APPLICATION NO.	FILING DATE	FIRST NAMED INVENTOR	ATTORNEY DOCKET NO.	CONFIRMATION NO.
10/743,091	12/23/2003	Keiji Nishimura	246949US3	8114
22850	7590	05/19/2005	EXAMINER	
OBLO, SPIVAK, MCCLELLAND, MAIER & NEUSTADT, P.C. 1940 DUKE STREET ALEXANDRIA, VA 22314			VERDIER, CHRISTOPHER M	
			ART UNIT	PAPER NUMBER
			3745

Office Action Summary

10/743,091

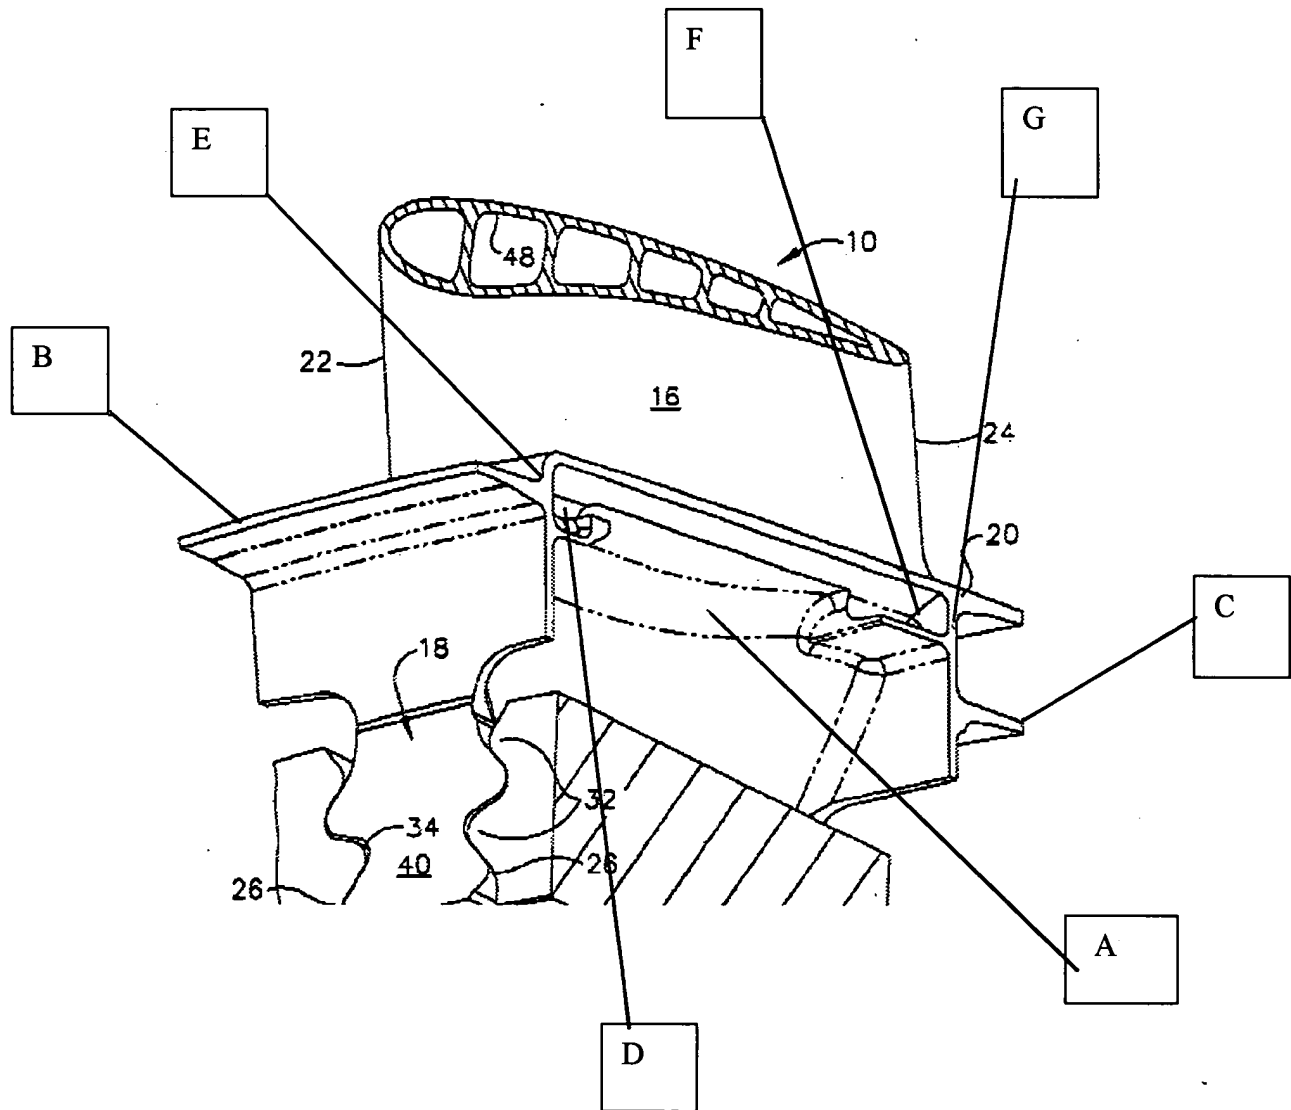
Claims 1-2 and 9 are rejected under 35 U.S.C. 102(e) as being anticipated by Herman 6,786,696 (see the annotated figure at the end of this paragraph). Note the turbine blade 10 to be installed into an engaged member 28 of a turbine disk 30 of an aircraft engine comprising a blade 10, one side of which having a convex suction surface and the other side of which having a concave pressure surface, a platform 20 on a hub side of the blade, a recess A being formed on one side of the platform, a front seal fin B formed protruding forward at the front end of the platform, and a rear seal fin C formed protruding backward at the back end of the platform, an engagement member 18 on the hub side of the platform, the engagement member having an engagement face 26 which is able to be engaged with the engaged member 28, a front engagement member D in the vicinity of a base portion of the front seal fin, the front engagement member having a front engagement face able to engage with a front locating portion of a jig to be used for grinding, and the front engagement face located back from a virtual plane including the one side of the platform; a front wall E in the vicinity of the base portion of the front seal fin, the front wall surrounding a front side-edge portion of the front engagement member, a rear engagement member F in the vicinity of a base portion of the rear seal fin, the rear engagement member having a rear engagement face able to engage with a rear locating portion of the jig, and the rear engagement face located back from the virtual plane, and a rear wall G in the vicinity of the base portion of the rear seal fin, the rear wall surrounding a rear side-edge portion of the rear engagement member, wherein an end face of the front wall and an end face of the rear wall are respectively configured to be coplanar with the virtual plane. The front engagement face and the rear engagement face are respectively configured to be substantially parallel to the longitudinal
